# The Calcutta Gazette

## APPENDIX.

### Notices to Mariners.

THE following Notices are republished for general information.

Reproduction of Portion of Chart N° 3726.

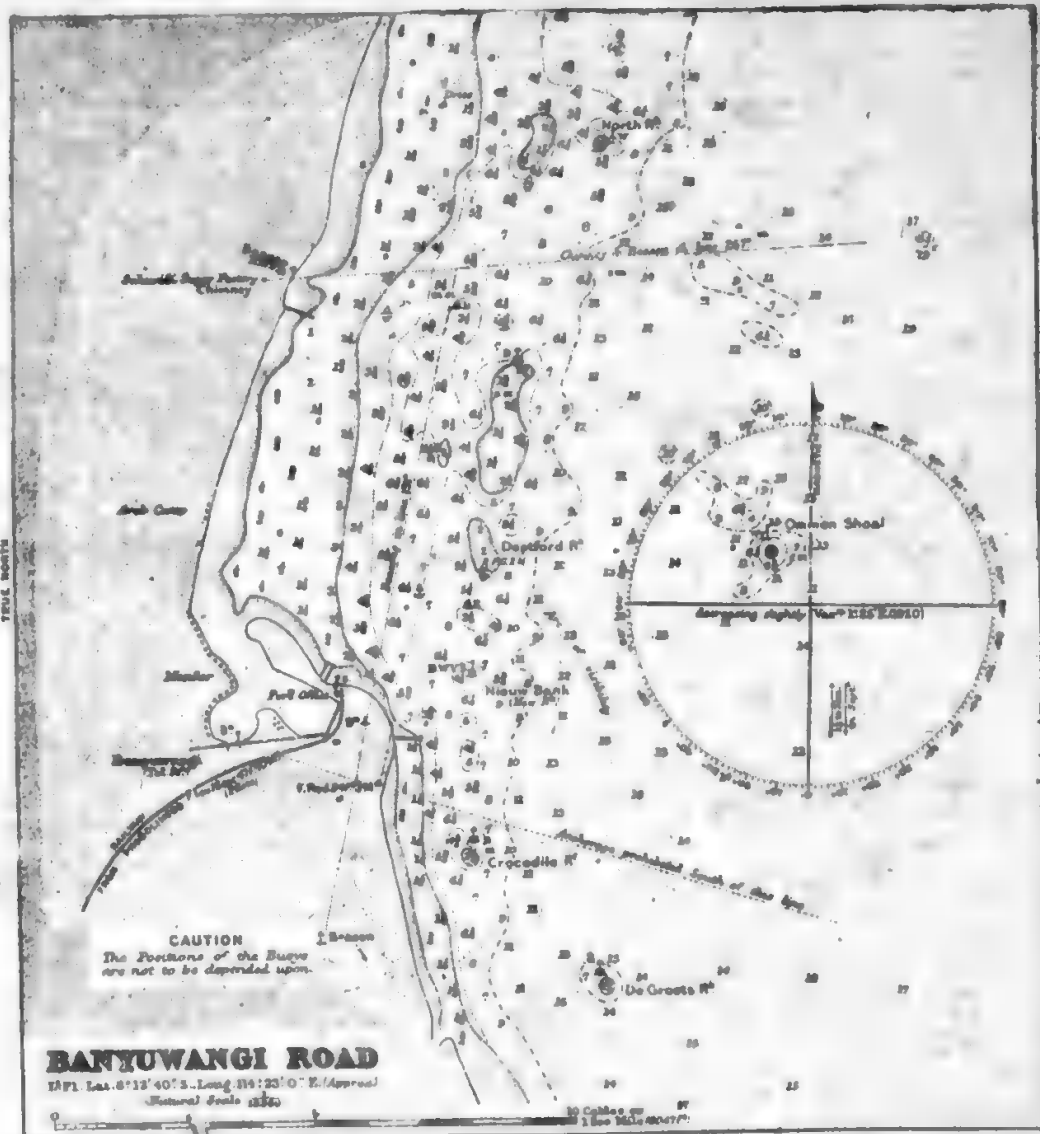
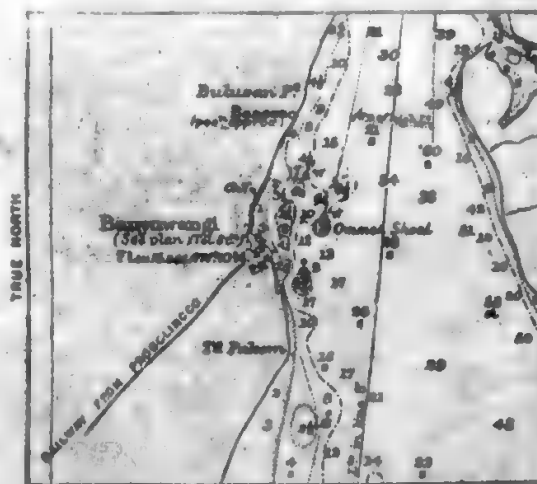
*Details.*—The accompanying reproduction of a portion of chart No. 3726, together with the plan quoted below, shows extensive amendments with regard to Banyuwangi road embodying the latest information received.

*Reproduction of Portion of Chart N° 3440.*

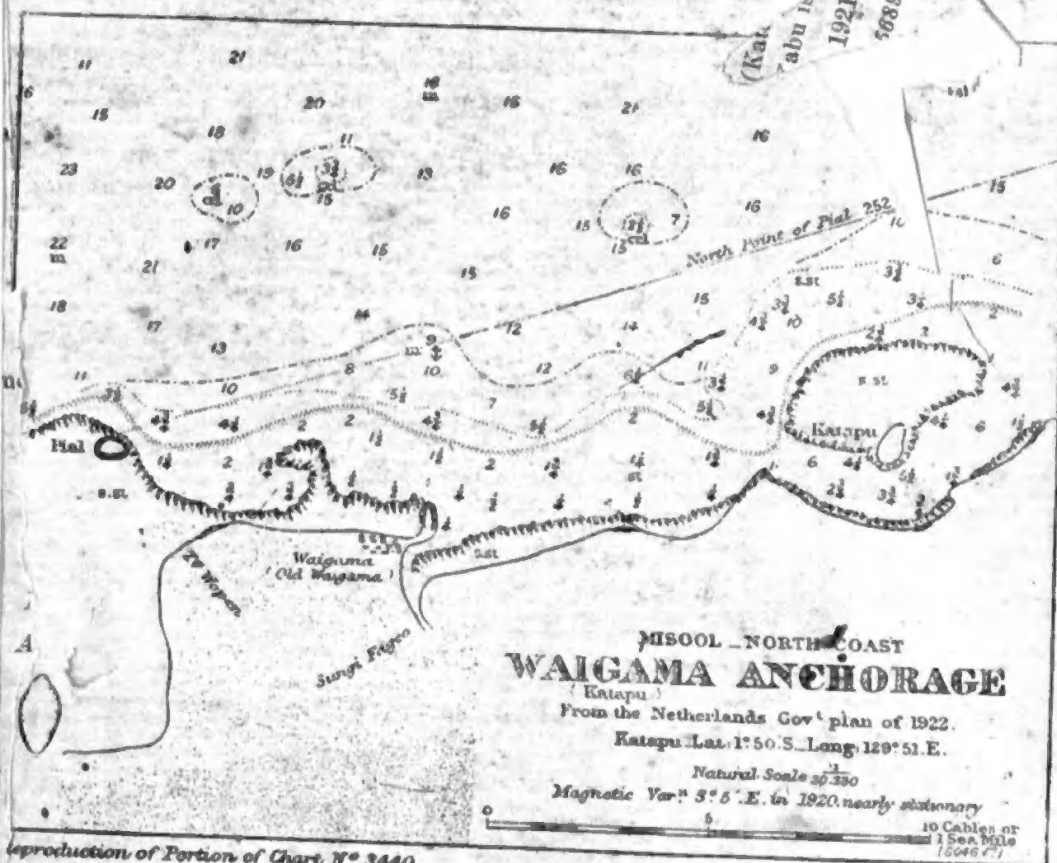
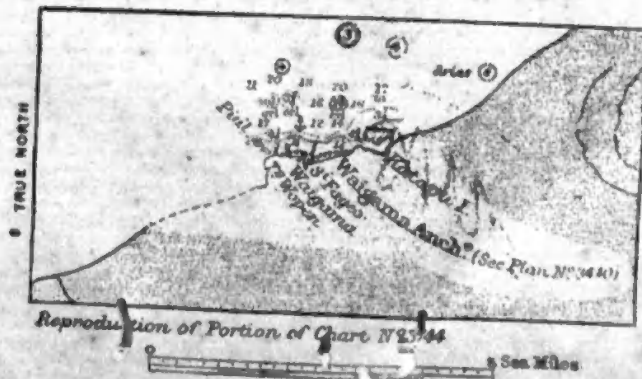
*Details.*—The accompanying reproduction of portions of charts, Nos. 3440 and 3744 show the necessary amendments with regard to Waigama (Katapu) anchorage. The existing plan of Katapu (New Waigama) anchorage on chart No. 3440 is to be replaced by the new plan of Waigama (Katapu) anchorage.
